ADDENDUM 1

ADDENDUM DATE: April 9th, 2019

PROJECT: OCSC Expansion - Phase 1, Seymour Center
2551 Homestead Rd.
Chapel Hill, NC 27516

The following is a list of changes that have been made to the plans since the issuance of bid documents. These changes are as a result of Town review comments.

C2-10

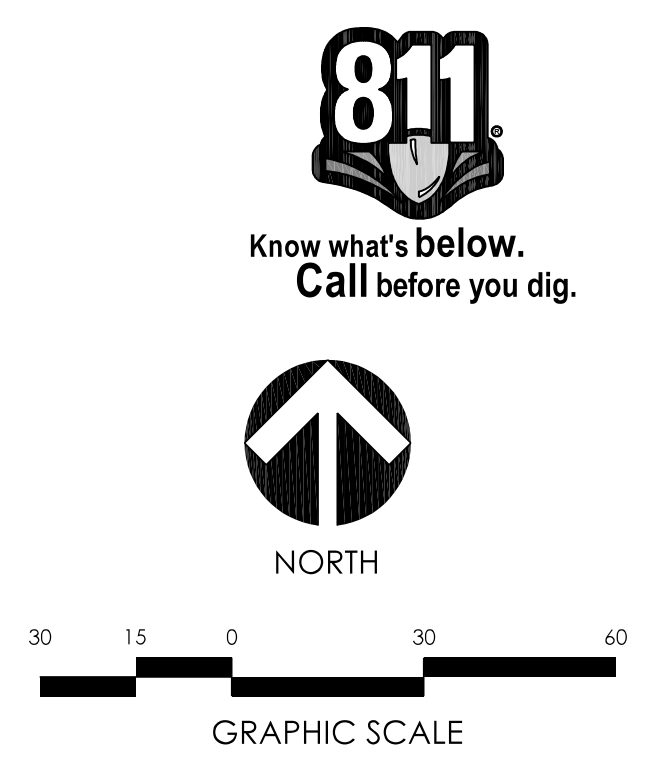
12. Town Required Construction Notes #1-7 have been added to sheet C0-01. (Refer to sheet C0-01)
13. An approximate location of a construction trailer has been shown on sheet C2-10. (Refer to C2-10)

C3-10

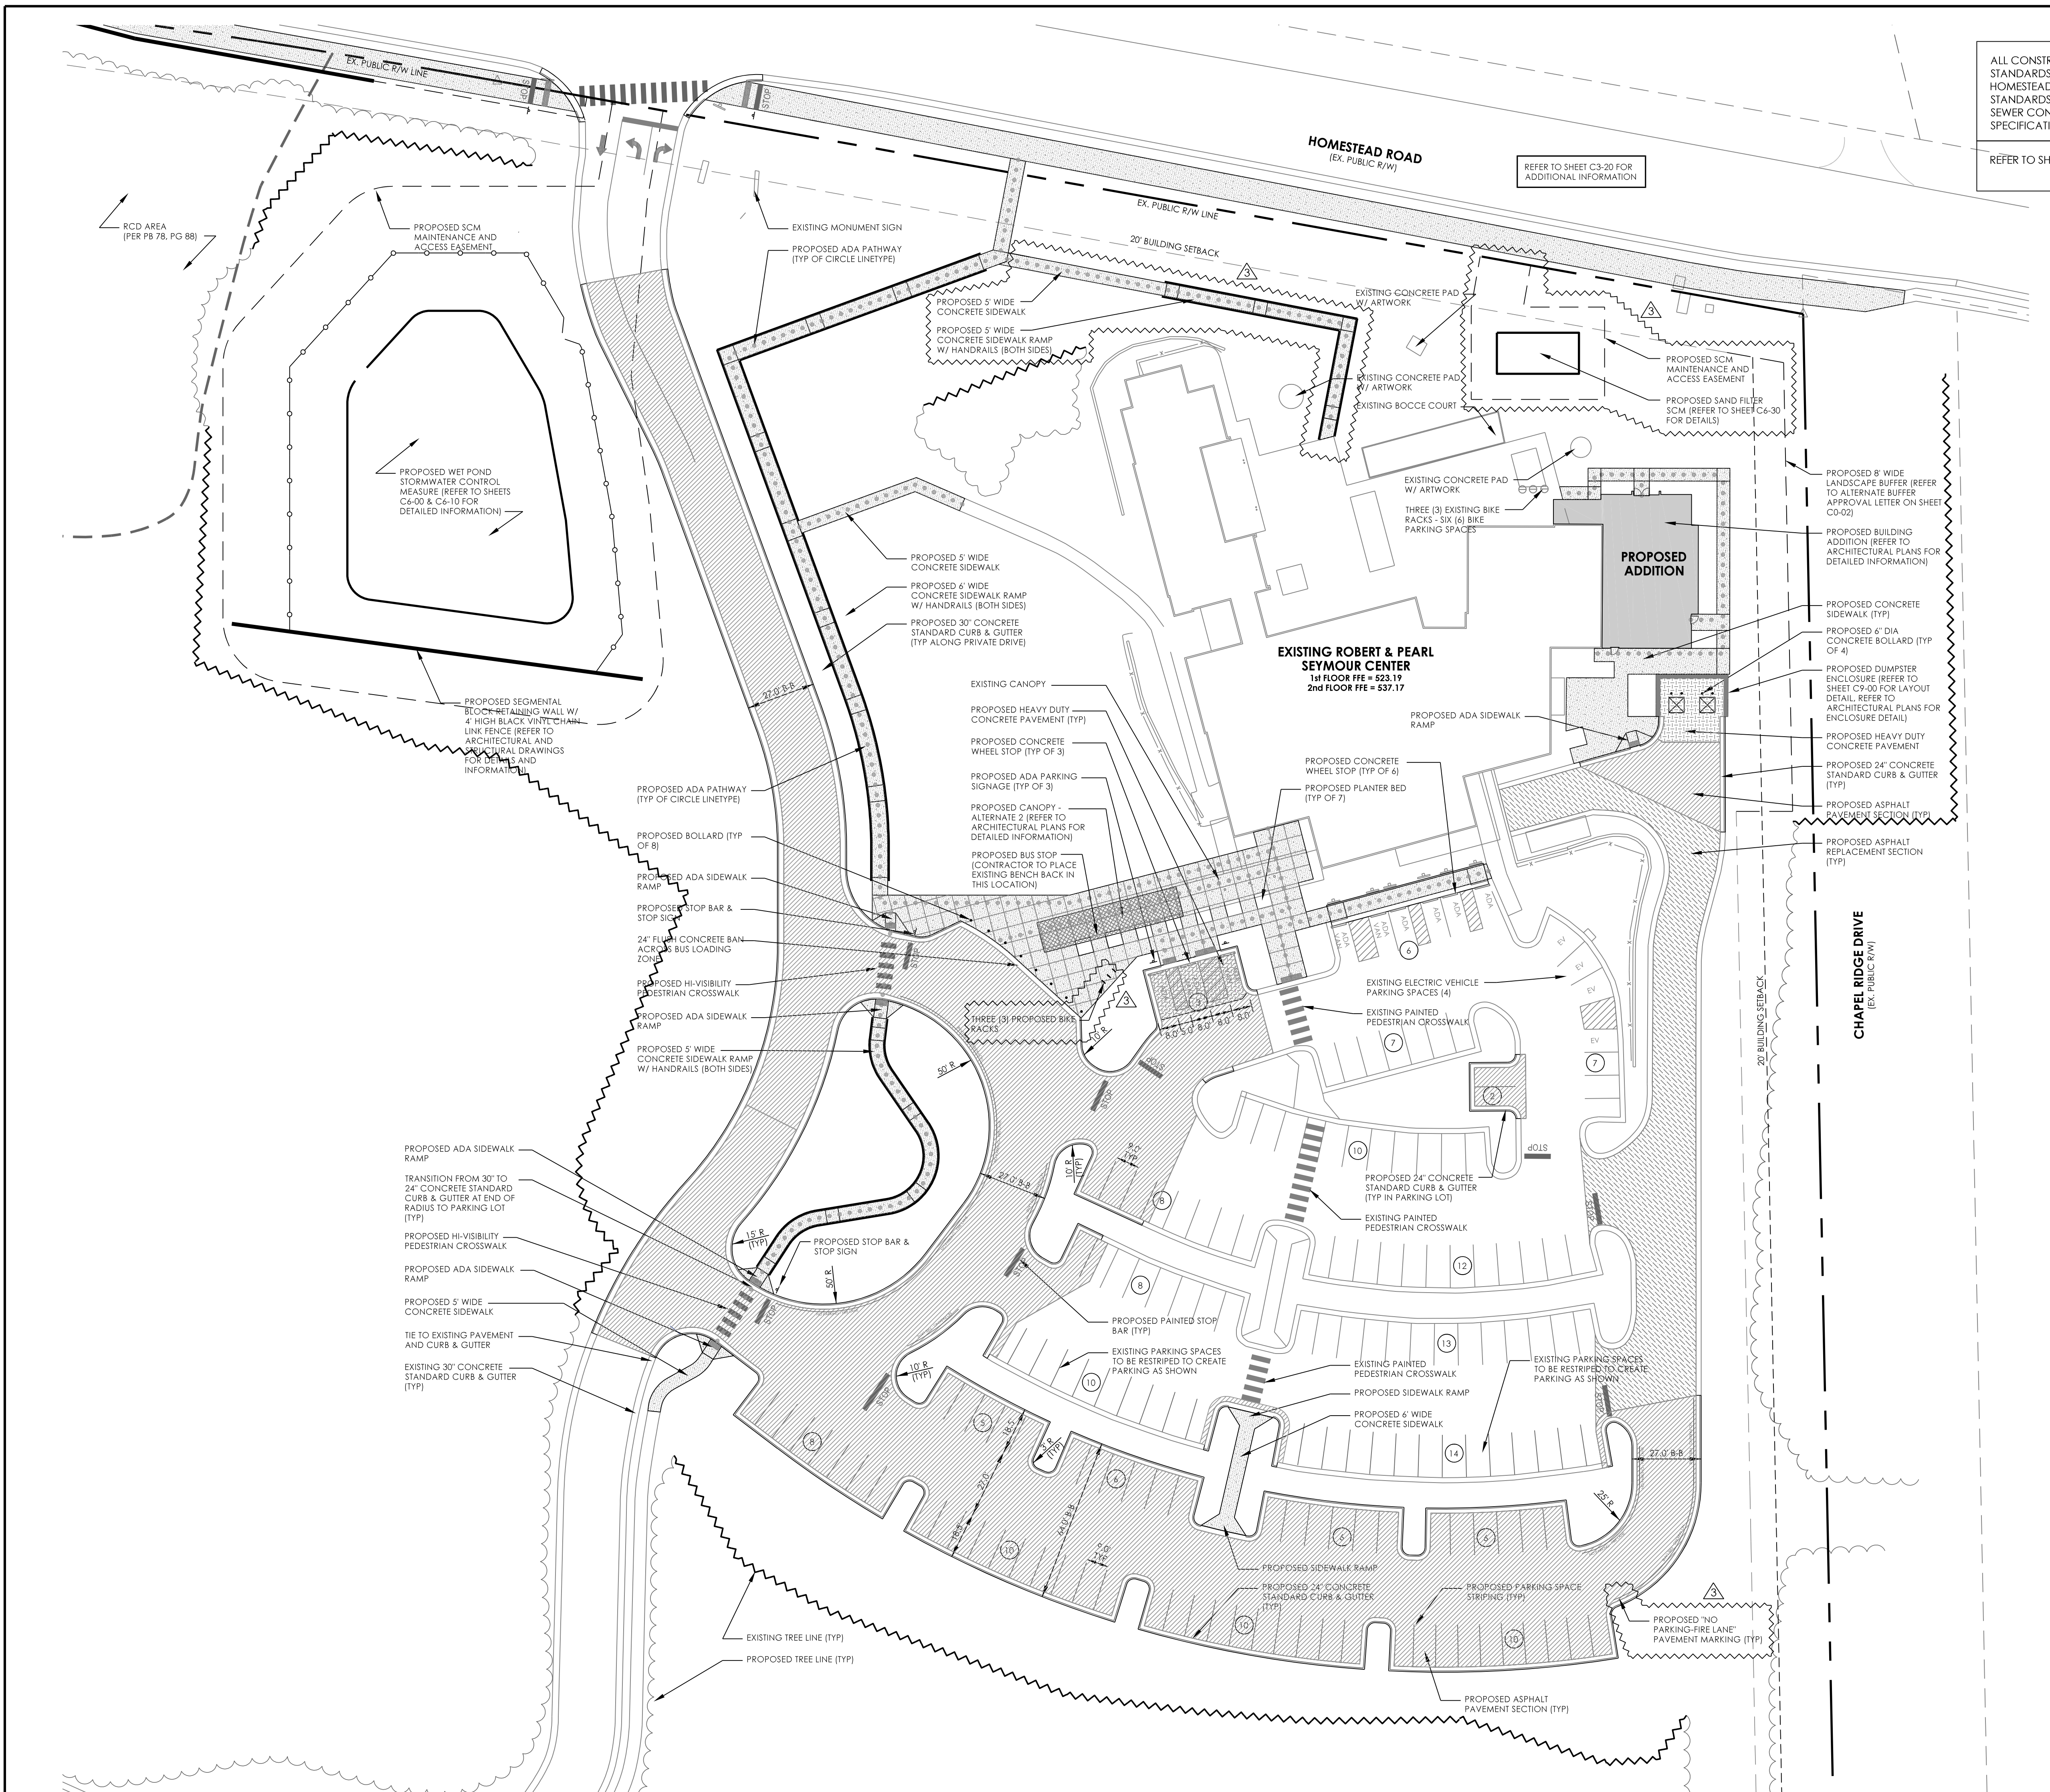
1. The new ADA accessible sidewalk on the north side of the building has been removed from the east side of the property. A new ADA sidewalk has been added from the existing plaza area to the proposed sidewalk on the west side of the project site. The contractor shall be responsible for constructing this sidewalk prior to demolishing the existing ADA sidewalk located on the northeast corner of the project area. (Refer to sheets C3-10, C3-20, C5-10, C5-20, and C5-40)

10. A bike rack has been added to the bus loading area. (Refer to sheet C3-10)
11. Site Accessibility Notes #4-7 have been added to sheet C0-01. (Refer to sheet C0-01)

16. "NO PARKING – FIRE LANE" pavement markings have been added on site. These markings have been shown on sheet C3-10 and a detail has been placed on sheet C9-02. (Refer to sheets C3-10 and C9-02)

C3-30

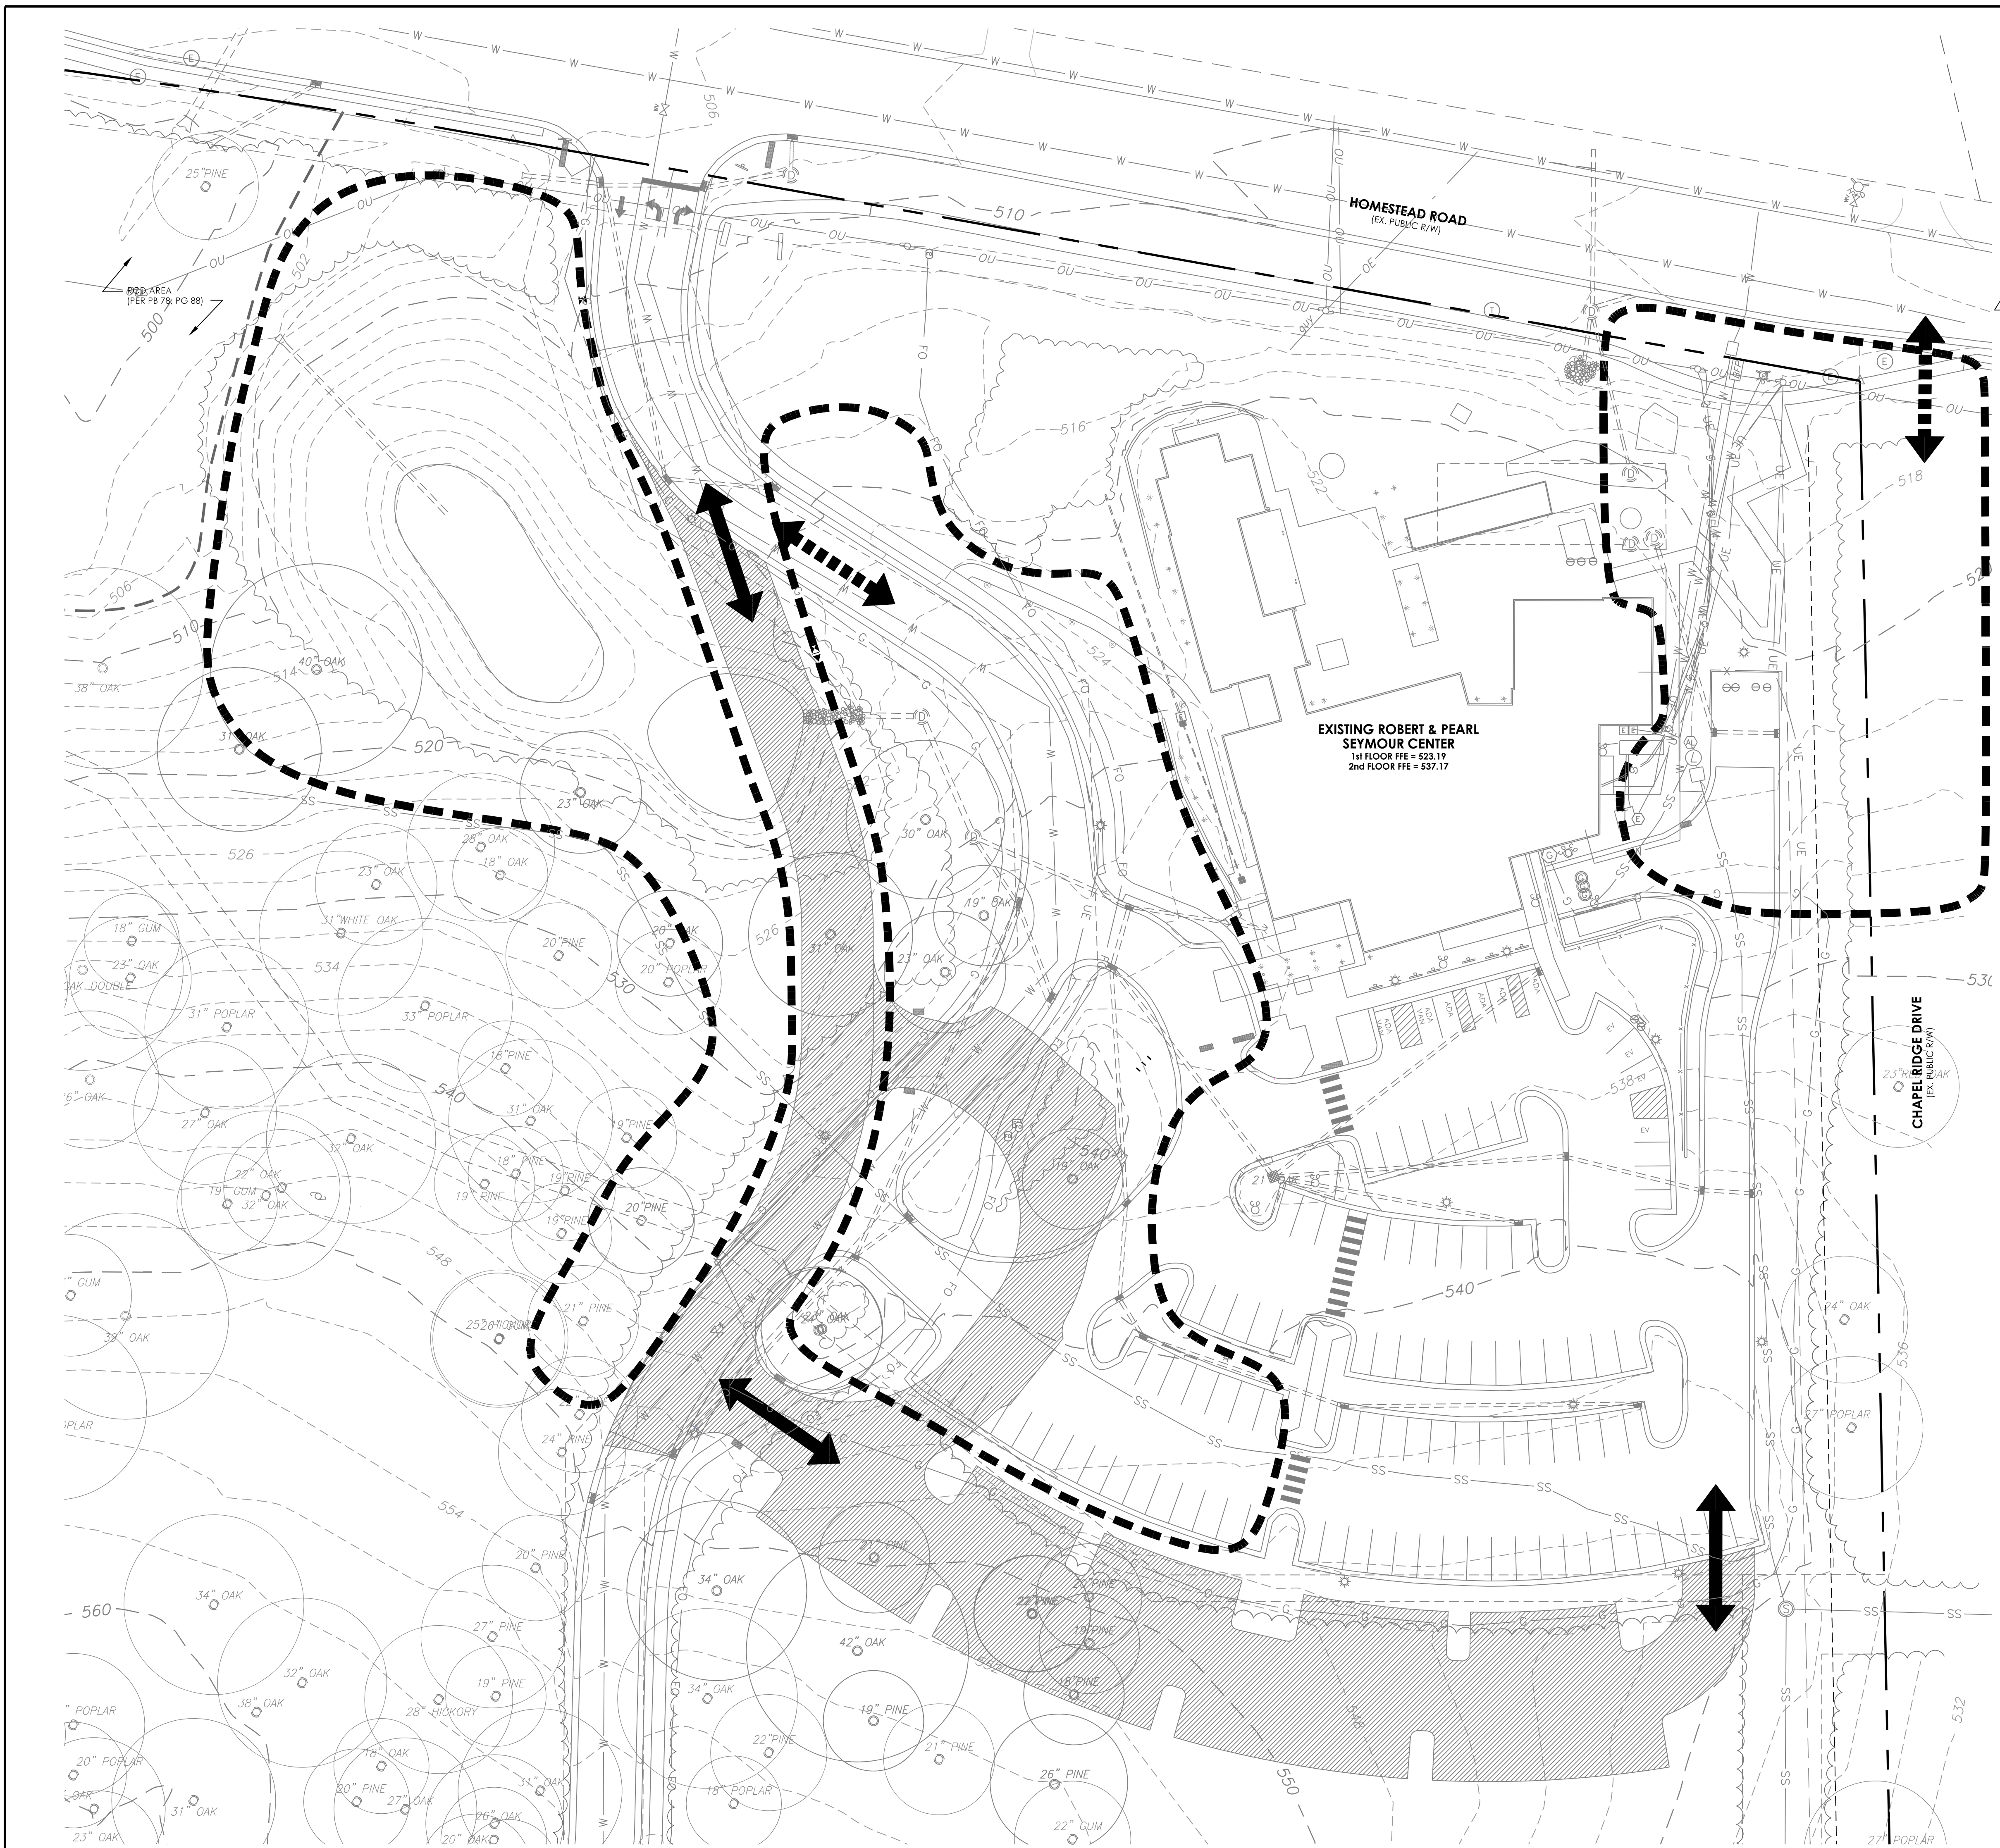
14. The ADA signage detail height has been revised on sheet C9-01. (Refer to sheet C9-01)
15. Construction Phasing Note #1 on sheets C3-30, C3-31 and C3-32 has been modified to required that 102 parking spaces remain available. (Refer to sheets C3-30, C3-31, and C3-32)
